North East Link Project

Statement of Evidence – Acoustics

Thomas Ross Evans

Expert of Manningham City Council

Figure 2 Extract from Figure J4 from Technical Report C

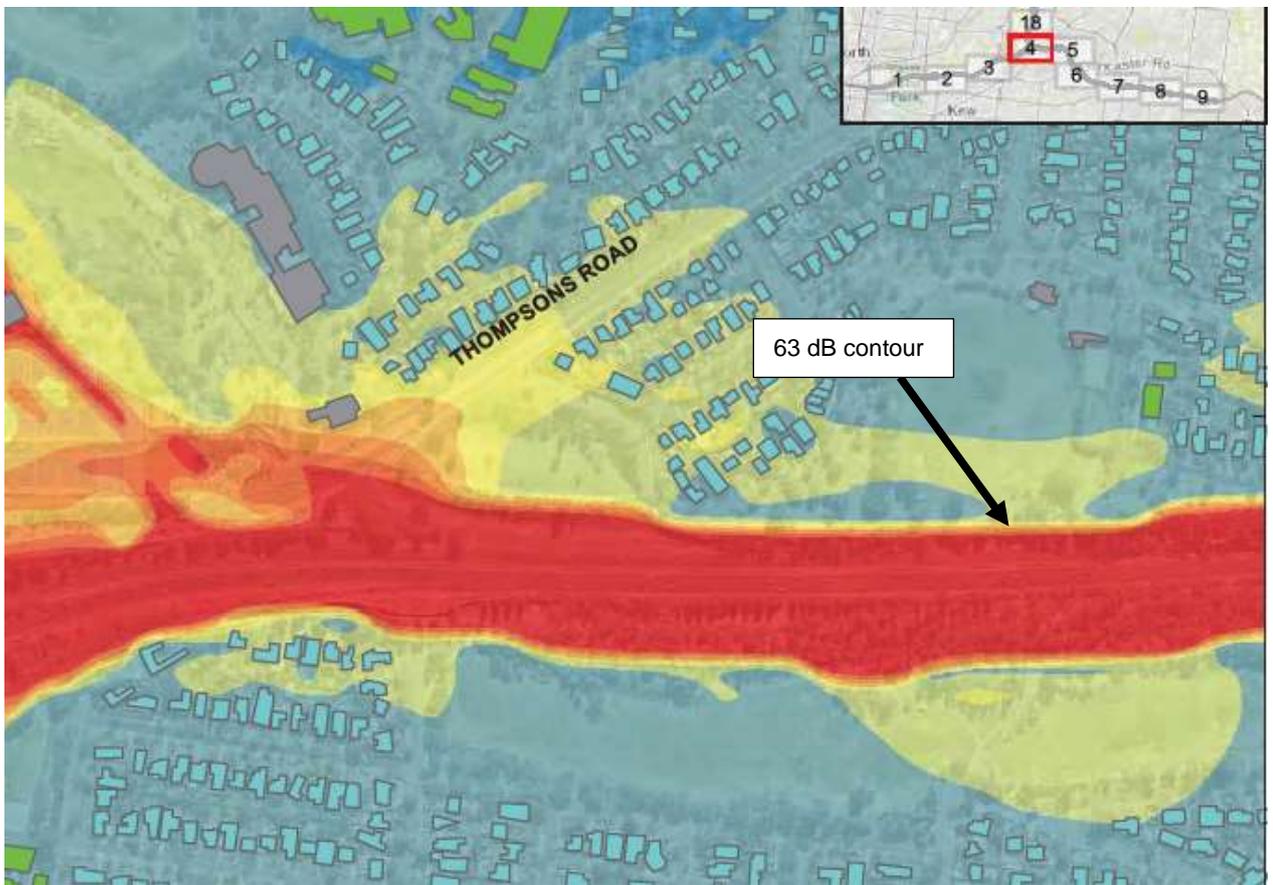
- 5.14 I was also advised by Mr Lindsey that the noise contour maps in Appendix J of EES Technical Report C were sufficient to identify the properties but note that this does not appear to be the case. For example, Figure J4 in Appendix J shows 2036 predicted noise contours for Noise Precinct 2, with road traffic noise levels below 63 dB shown for all residential properties despite 13 properties being identified for additional at-property treatment in this area in Section 9.5.3.3 of the Technical Report. I consider that this matter requires clarification generally throughout Noise Precinct 3 and Noise Precinct 4.

- 5.18 My primary concern is that, while the reference design assessed in the EES is predicted to achieve these outcomes, there is no requirement under the proposed EPRs for an assessment of noise within these spaces. This introduces the risk that a detailed design could change noise levels within the parks and open spaces, resulting in markedly different outcomes to those stated within the EES.
- 5.19 In some cases, such as the new 10 m high noise wall protecting the Bulleen Cricket Club Reserve, the noise contours on Figure J4 (refer extract as Figure 2 below) appear to indicate that the noise wall may not be required to achieve the project noise levels at the residences in the vicinity. This presents a risk that the noise wall could be reduced in size or removed during detailed design unless a formal requirement to provide a noise wall is documented in the EPRs.

- 5.20 While I acknowledge that there is no requirement under the VicRoads *Traffic Noise Reduction Policy* to provide protection to open space, I note that a comparable recent project (the West Gate Tunnel Project) committed to providing noise walls of a specified height in the EPRs to do just this.

- 5.21 The recently released Minister's Assessment for the Mordialloc Bypass has also recommended that noise attenuation be provided to public open space, primarily to minimise the noise impact on fauna but also giving consideration to passive recreation areas.
- 5.22 Given the above, I recommend adoption of an EPR to address road traffic noise at parks and open spaces that either:
- Commits to the noise wall heights stated in the EES, with the addition of specific information around the flood walls OR
 - Commits to a noise wall design that achieves consistent noise outcomes with the EES at parks and open space (e.g. within 2 dB), to ensure consistency with the EES.

Figure 3 Extract from Figure J5 from Technical Report C

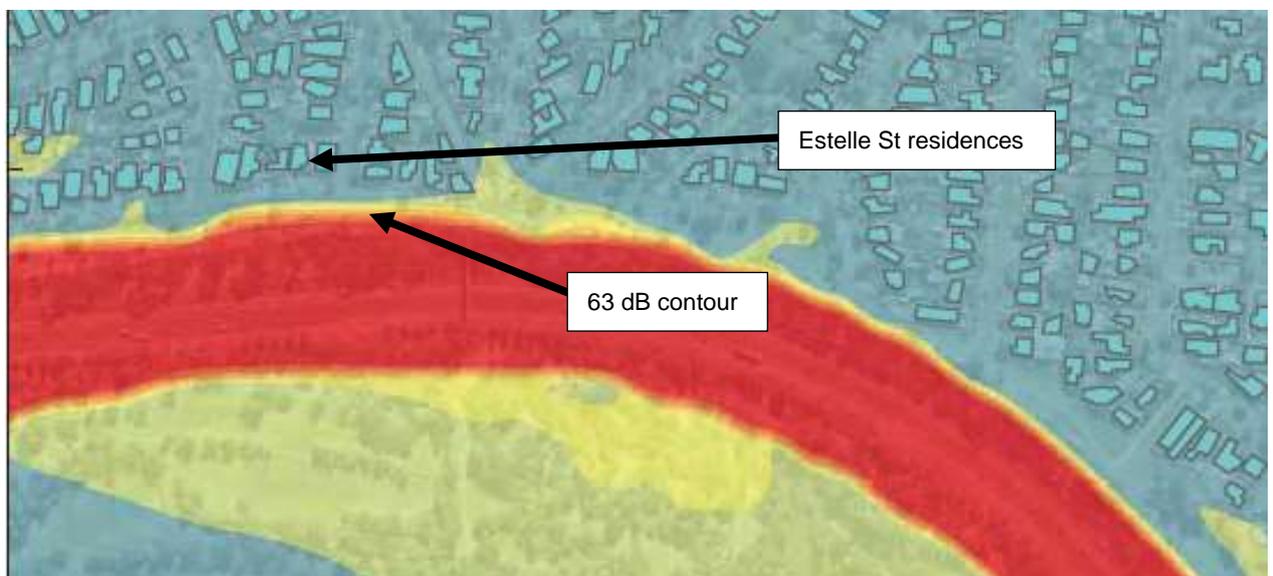
7.2 I understand that Council has concerns that the proposed new 10 m high noise wall along Estelle Street in Bulleen may have amenity impacts on Estelle Street residences. The new 10 m high noise wall is proposed closer to the residences than the current noise mound and timber wall combination to allow for the busway to be constructed where this existing barrier is located.

7.3 Decreasing the height of the wall would result in increased predicted road traffic noise levels behind the wall. However, I note that, based on the noise contours shown in Appendix J of Technical Report C, it appears that a reduction in noise wall height may be possible whilst maintaining compliance with the 63 dB noise criterion, as shown by the extract of Figure J5 included as Figure 3.

- 7.4 Based on Appendix J of Technical Report C, the predicted road traffic noise levels at the Estelle Street houses appear to be lower than 55 dB $L_{A10,18h}$. It is not possible to give an accurate measure of the reduction in noise wall height that would be possible but, assuming that the contours in Appendix J are correct, it would appear reasonable to me that the barrier height could be reduced by at least 20% and would still achieve compliance with the 63 dB $L_{A10,18h}$ criterion.

- 7.5 Another method that could be used to reduce the height of the barrier, either in combination with the above or not, would be a relocation of the Eastern Freeway and busway further to the south. This would potentially allow for the new barrier to be installed on the existing mound in this area.

- 7.6 I also note that the requirements for noise mitigation must be balanced against other potential amenity impacts. If the Estelle Street barrier were to remain at its current location and a 10 m barrier is required to achieve compliance with the noise criteria, then a reduction in height to reduce overshadowing could be carried out with the provision of supplementary at-property treatments to affected residences. In my opinion, matters such as this can be resolved through my proposed addition to the EPRs requiring submission of an Operational Noise Assessment Report for the detailed design.
